North Eastern Regional Power Committee

Sub: 81वीं संरक्षण समन्वय उप-समिति (पीसीसी) बैठक का कार्यवृत्त/ Minutes of 81st Protection Coordination Sub-Committee (PCC) Meeting

81st Protection Coordination Sub-Committee Meeting

Date: 24/07/2025 (Thursday)

B.9 Grid Disturbance in Mynkre area and Leshka HEP of Meghalaya Power System on 1st June'25:

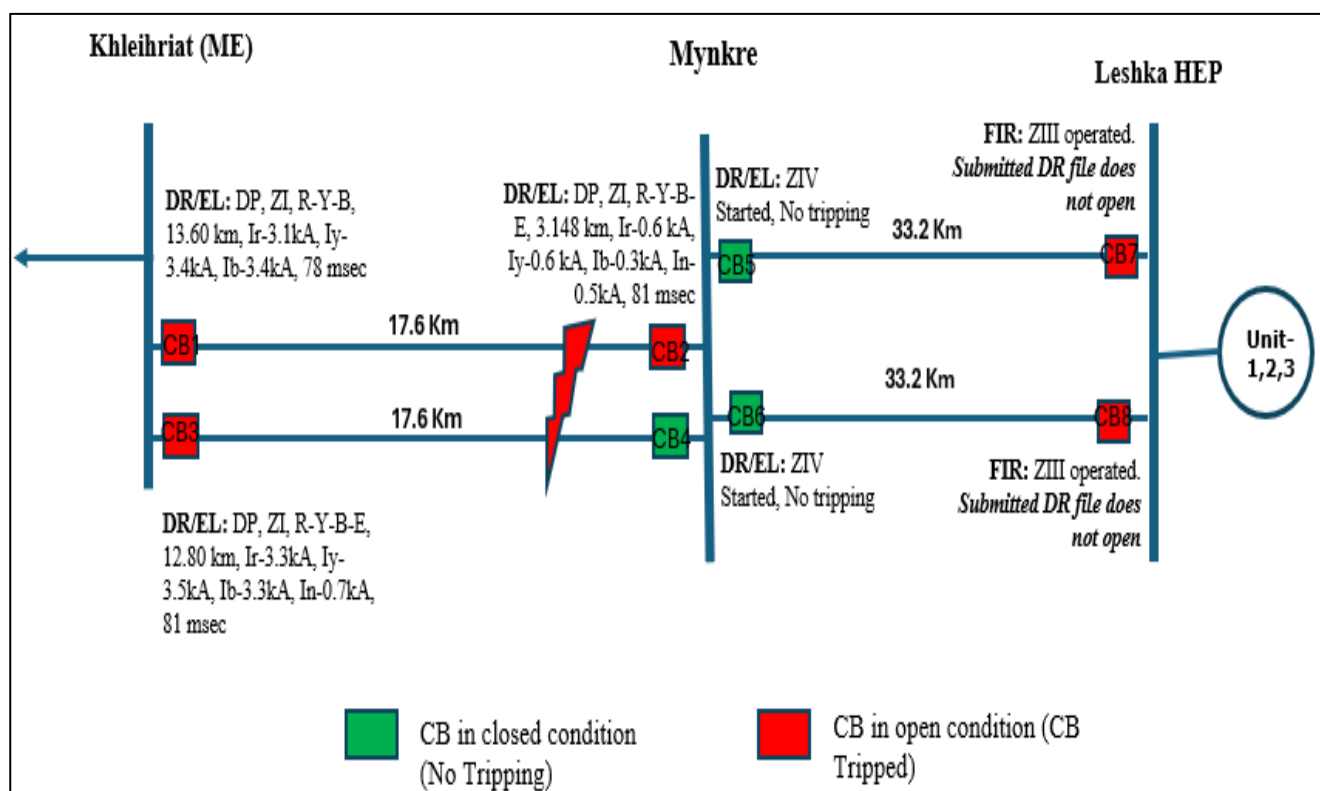
At 05:37 Hrs of 01-06-2025, 132kV Mynkre (ME)- Khliehriat(ME) D/C lines and 132kV Mynkre-Leshka D/C lines tripped resulting in grid disturbance in Mynkre area and Leshka HEP of Meghalaya Power System. Generation loss of 84 MW occurred.

As per DR analysis of 132 kV Mynkre (ME)-Khliehriat(ME) 1 line, solid R-Y-B fault (Ir-3.1 kA, Iy-3.4 kA, Ib-3.4 kA) initiated at 05:37:08.630 Hrs which was cleared within 81 msec on operation of DP, ZI.

B.10 Grid Disturbance in Ningthoukhong area of Manipur Power System on 9th June'25:

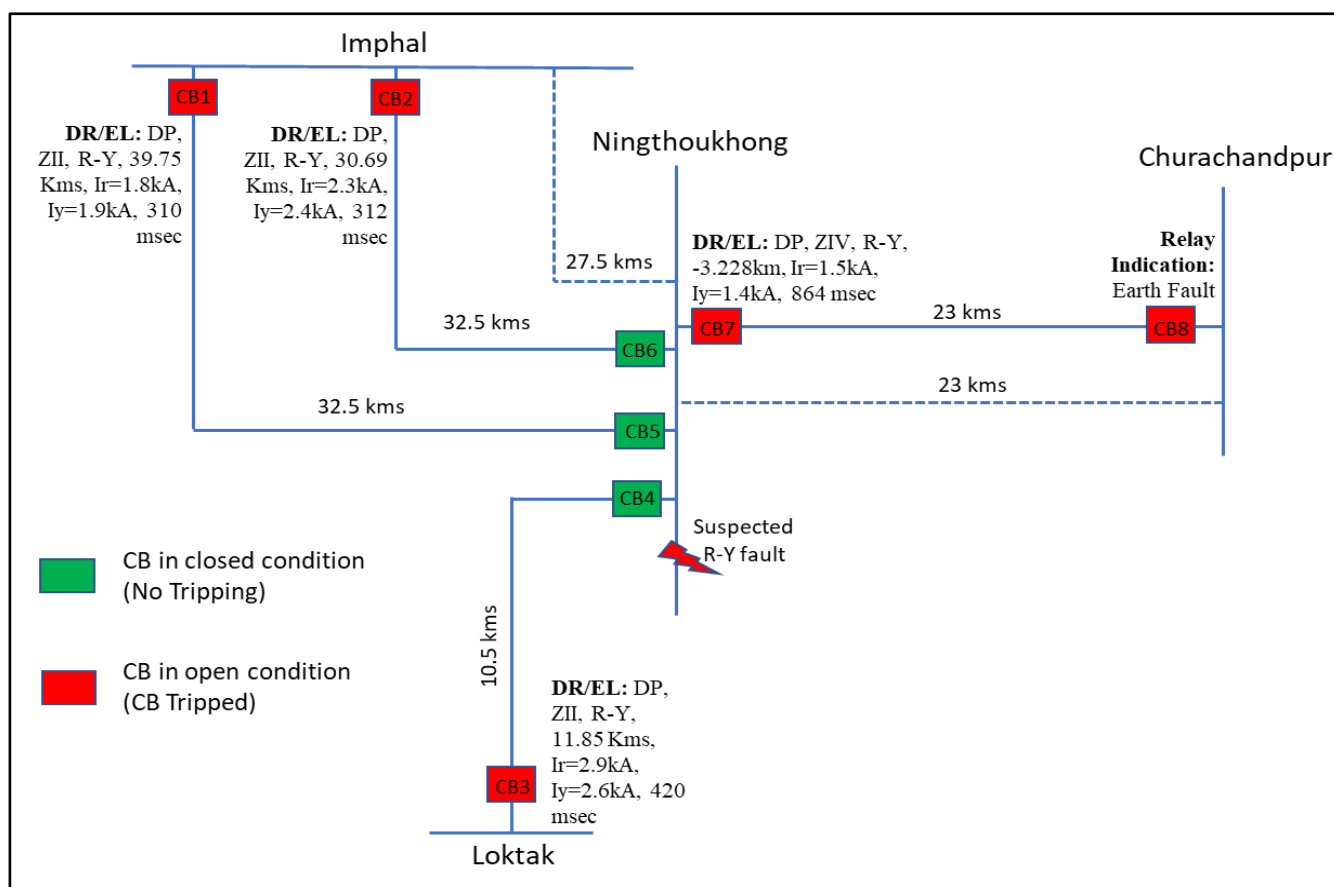
At 13:34 Hrs of 09-06-2025, 132 kV Imphal-Ningthoukhong ckt 2, 132 kV Imphal-Ningthoukhong ckt 3, 132 kV Loktak-Ningthoukhong, 132 kV Ningthoukhong-Churachandpur 2 tripped. Due to tripping of these elements, Ningthoukhong area of Manipur Power System got isolated from NER Grid and collapsed due to no source available in this area. Load loss of 9 MW occurred.

MSPCL to share the root cause of the event and provide update on the above-mentioned issues.

B.11 Grid Disturbance in Dharmanagar area of Tripura Power System and Dullavchera area of Assam Power System on 10th June'25:

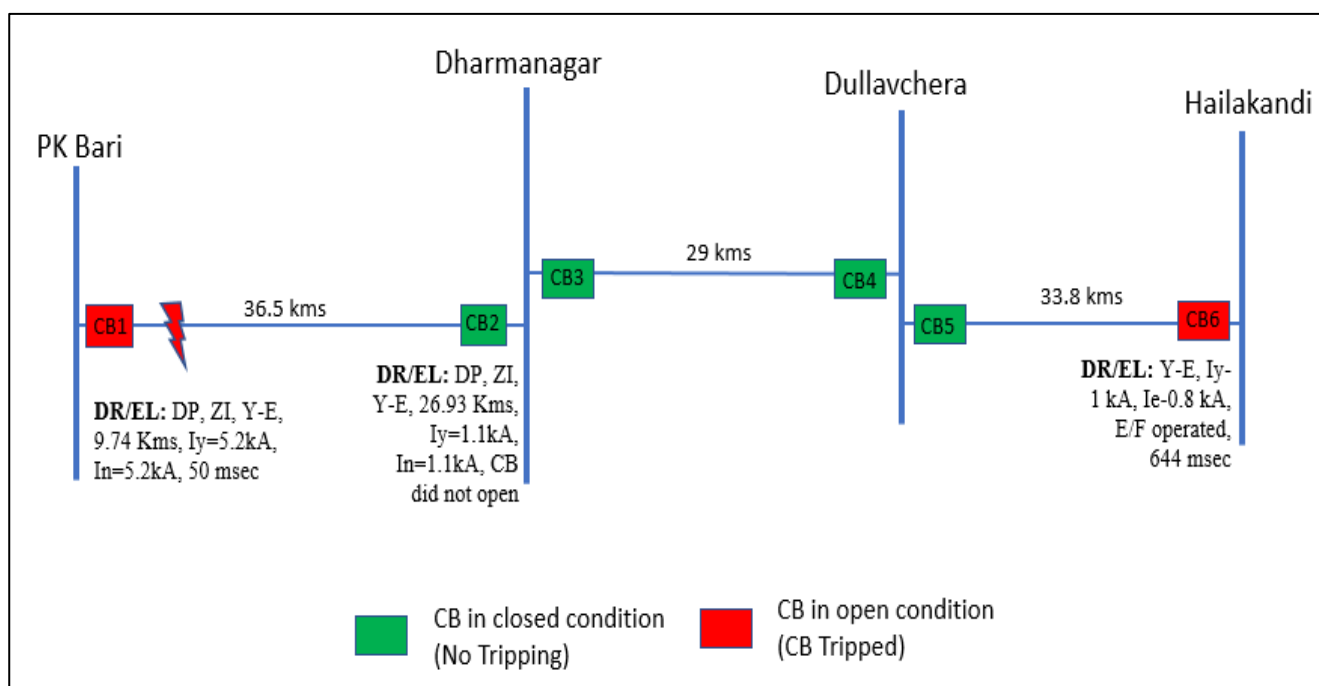
At 18:45 Hrs of 10-06-2025, 132 kV Dharmanagar-PK Bari line & 132 kV Hailakandi-DULLavchhhera line tripped resulting in grid disturbance in Dharmanagar & Dullavchhhera areas. Load loss of 35 MW occurred.

As per DR analysis, Y-N fault ($I_b=5.2\text{ kA}$, $I_n=5.2\text{ kA}$) initiated at 18:40:57.118 Hrs which was cleared within 50 msec from PK Bari on operation of DP, ZI. At Dharmanagar end, ZI trip command issued at 18:25:30.360 Hrs. However, CB did not open at Dharmanagar due to which fault was continuously feeding from Dullavchhara & Hailakandi end. Fault cleared by tripping of healthy 132 kV Hailakandi-Dullavchhara line within 644 msec from Hailakandi end on operation of E/F (DT send).

Event 1: At 12:26 Hrs of 14.06.2025- Load Loss of 23 MW & Generation Loss of 7.2 MW

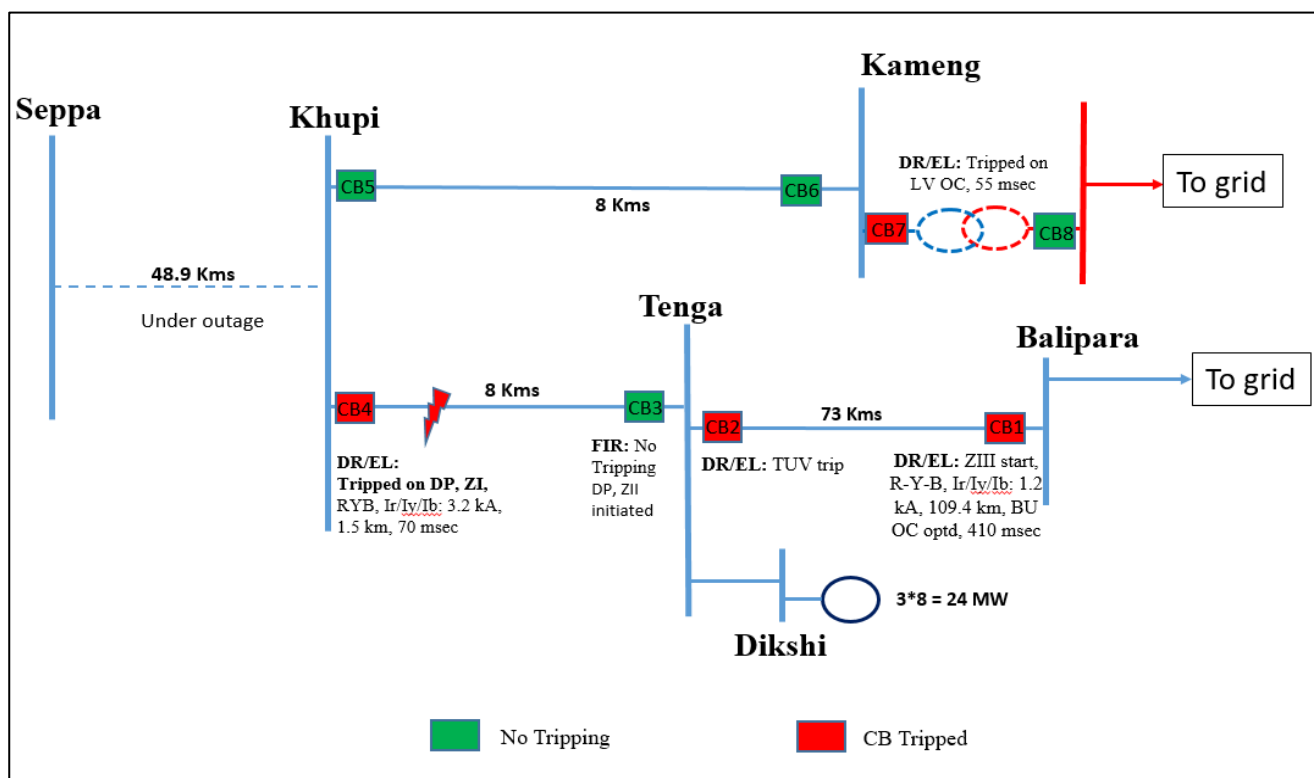
As per available DR & EL data, 3 phase metallic fault initiated in the 132 kV Khupi – Tenga line cleared from Khupi end in DP, ZI, RYB, Ir/Iy/Ib: 3.2 kA, 1.5 km in 70 msecs. Tenga end located the fault in ZII (as per FIR).

- Non-operation of protection system at Tenga for 132 kV Khupi line.
- Tripping of 132 kV Balipara – Tenga line on operation of OC within 410 msecs. Overcurrent TMS need to be coordinated with ZII timing of CB3.
- Tripping of ICT at Kameng on LV side on operation of Backup DT OC within 55 msecs seems unwanted.

Event 2: At 10:28 Hrs of 23.06.2025- Load loss of 34 MW & generation loss of 10 MW

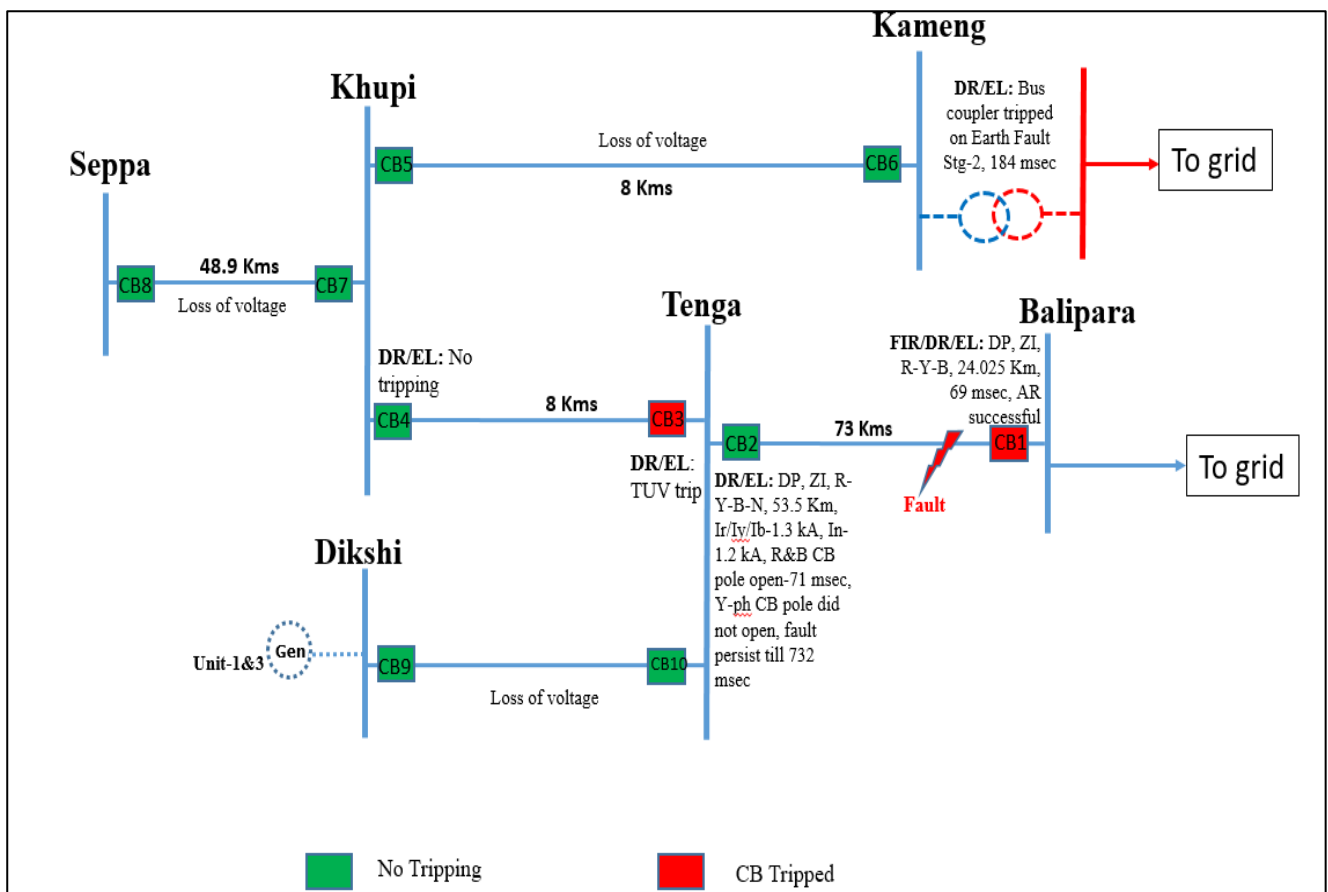
As per DR analysis, solid R-Y-B-N fault occurred in 132 kV Balipara-Tenga Line at distance of 53.5 Km from Tenga end which was cleared within 69 msec from Balipara end on operation of DP, ZI (AR successful). ZI trip command issued from Tenga end and R & B-phase CB pole opened after 71 msec. However, Y-ph CB pole did not open and fault current persisted till 732 msec.

Regarding tripping at Balipara end, Forum asked DoP Ar. Pradesh to revise the OC and EF settings to follow the NERPC protection settings protocol.

Regarding unwanted tripping of Kameng ICT, NEEPCO informed that LV side pickup for DT OC revised to 4620 A.

Event 1:

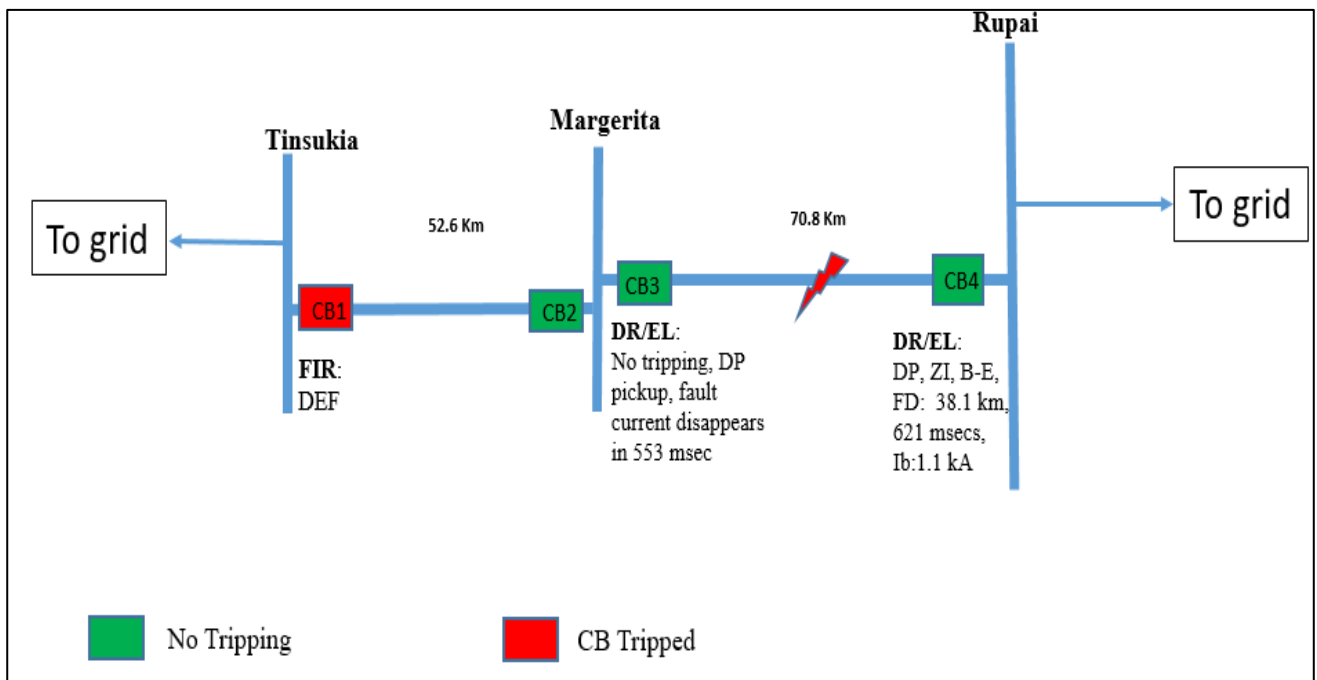
As per DR analysis, at 10:50:26.946 Hrs, high resistive B-E fault (Ib-1.1 kA, Vbe-51 kV) appears in 132 kV Rupai-Margherita line at a distance of 38.1 Km which was cleared from Rupai end within 621 msec on operation of DP, ZI. No tripping observed at Margherita end (DP pickup, fault current disappears within 553 msec).

- Protection system at Margherita end for 132 kV Rupai Line failed to isolate the fault leading to clearing of fault by tripping of healthy 132 kV Margherita-Tinsukia line from remote end.
- Time drift of 3 min observed at Rupai end for 132 kV Margherita Line.

Event 2:

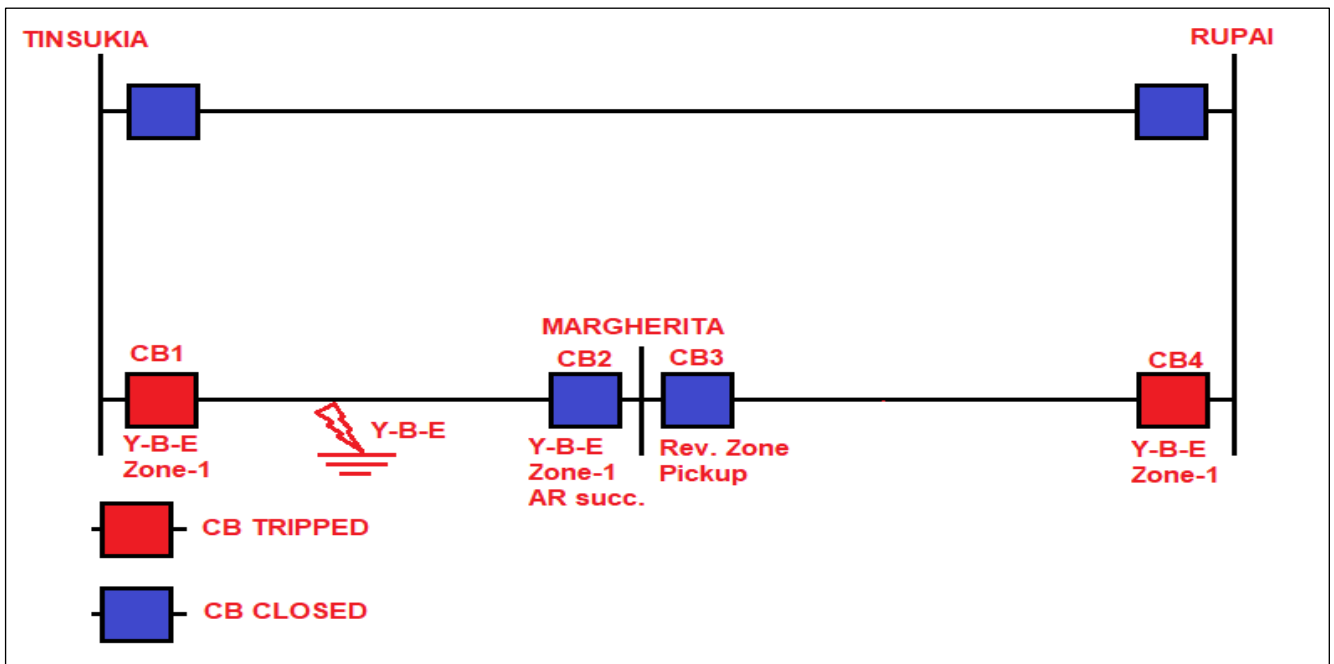
As per DR analysis, Y-B-E fault in 132 kV Tinsukia – Margherita line cleared from Tinsukia and Margherita end in 90 msecs on operation of DP, ZI. Margherita end (CB2) successfully auto-reclosed.

Forum noted that zone 1 at Rupai for 132 kV Margherita line is overreaching and requested AEGCL to revise the reach of Zone1 protection. AEGCL informed S/D will be taken for testing of relay.

B.15 Grid Disturbance in Leshka, Mynkre, Mustem and IIM areas of Meghalaya Power System on 19th June'25:

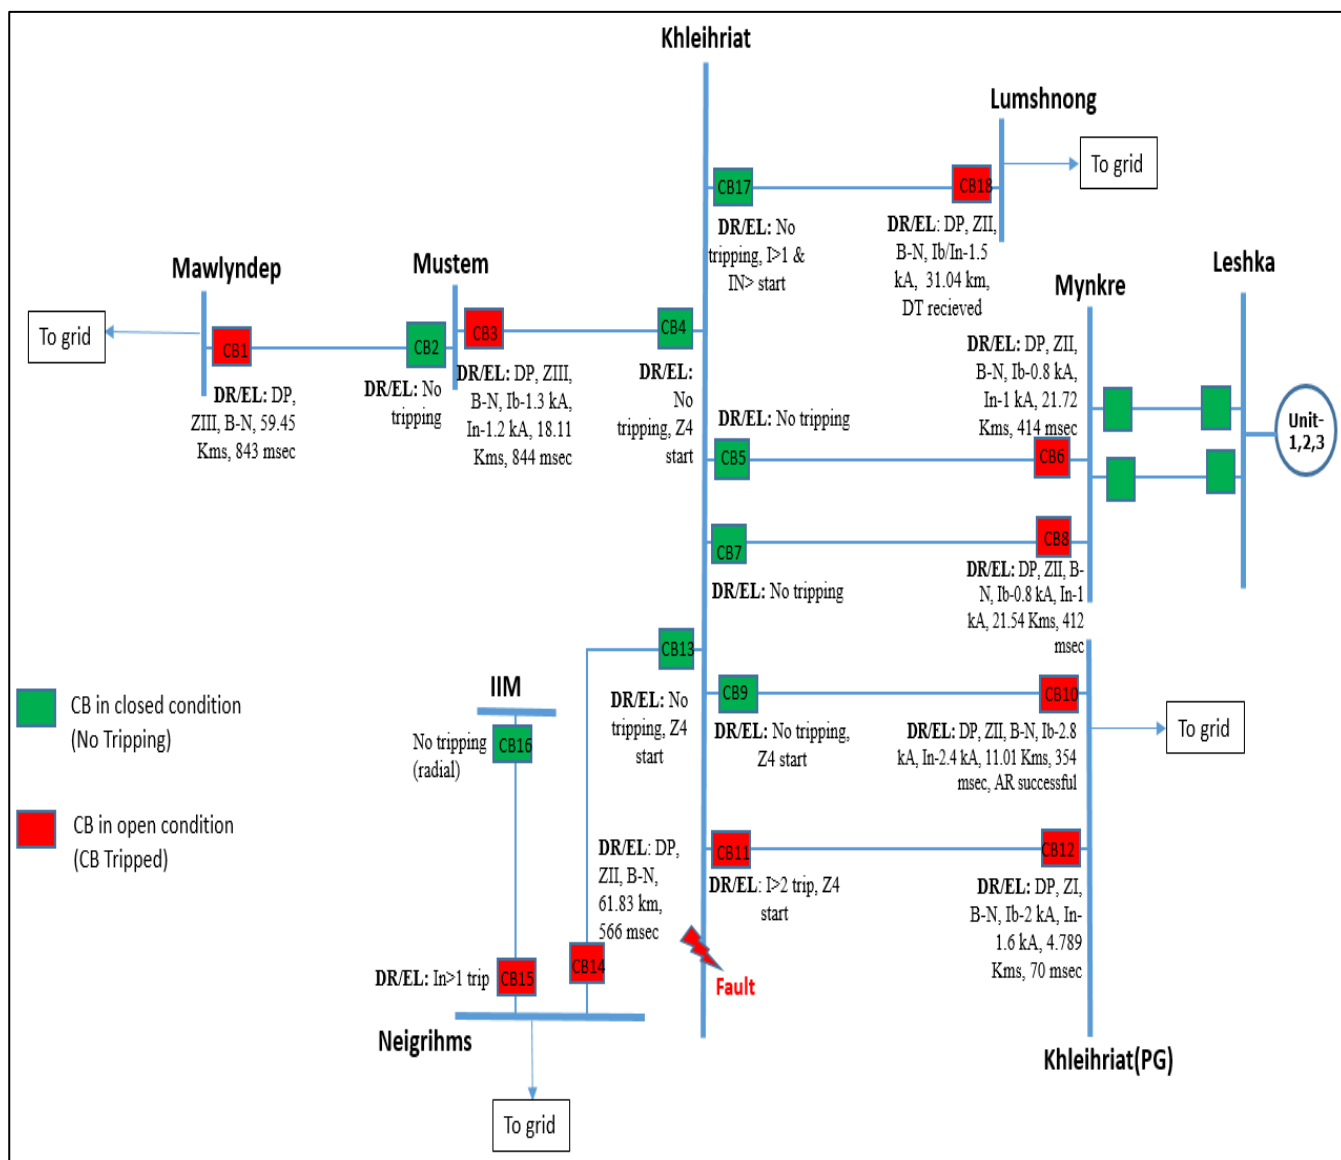
At 14:00 Hrs of 19-06-2025, all the lines connected to 132 kV Khleihriat Bus except 132 kV Khleihriat-Khleihriat(PG) I line, 132 kV Mawlyndep-Mustem & 132 kV Neigrihms-IIM lines tripped. Due to these tripping, Leshka, Mynkre, Mustem and IIM areas of Meghalaya Power System got isolated from NER Grid and collapsed due to no source available in these areas.

- Tripping of 132 kV Mustem-Khleihriat line on Z3 from Mustem end is inferred unwanted. Z3 reach setting needs to be reviewed and revised as per NER protection philosophy.

3. Considering the criticality of 132 kV Khleihriat S/S in Meghalaya power system, Forum advised MePTCL to consider upgrading the existing single bus scheme to a Double Main Cum Transfer scheme.

B.16 Multiple tripping in Ningthoukhong S/S of Manipur power system on 20th June'25:

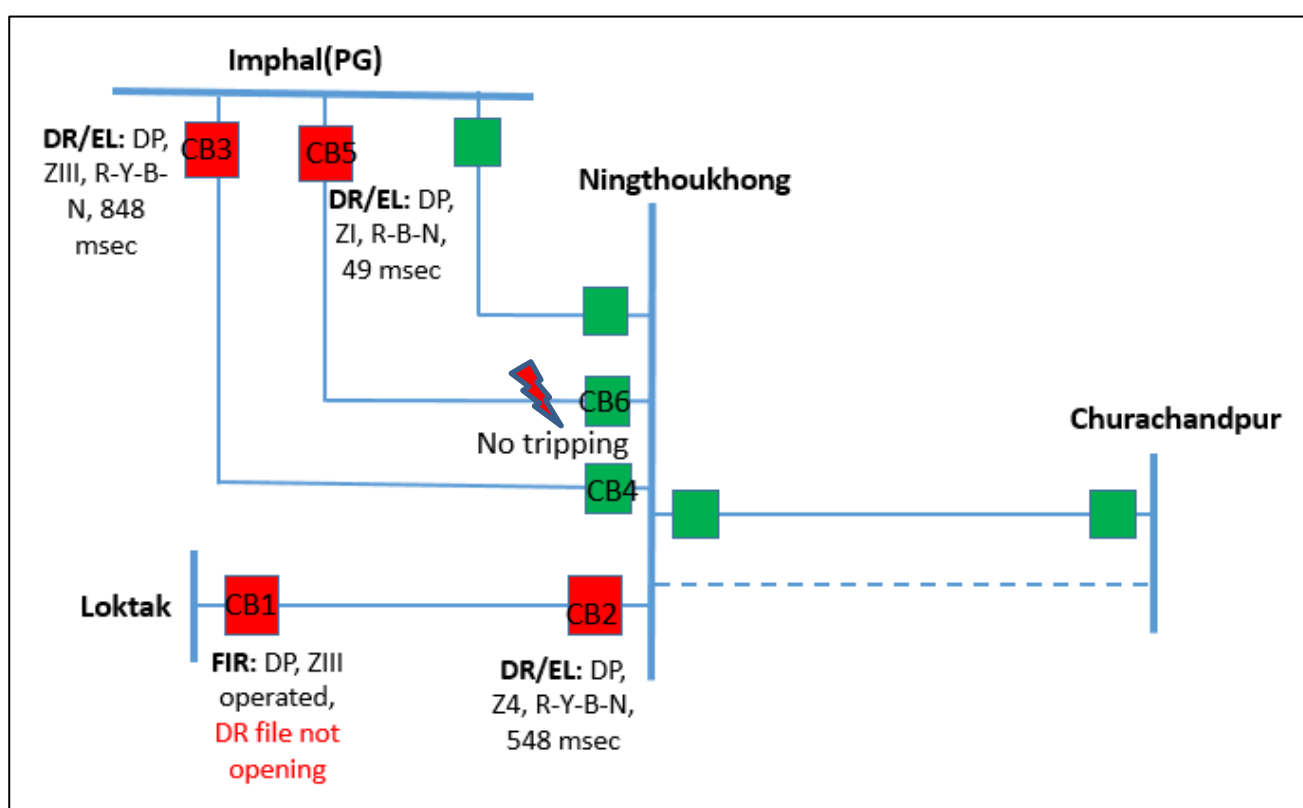
As per DR analysis, solid R-B-N fault (Ir-2.4 kA, Ib-0.8 kA, In-1.7 kA) initiated at 03:52:00.925 Hrs which was cleared within 49 msec from Imphal(PG) end on operation of DP, ZI. There was no tripping from Ningthoukhong due to which fault was continuously feeding from other lines at Ningthoukhong.
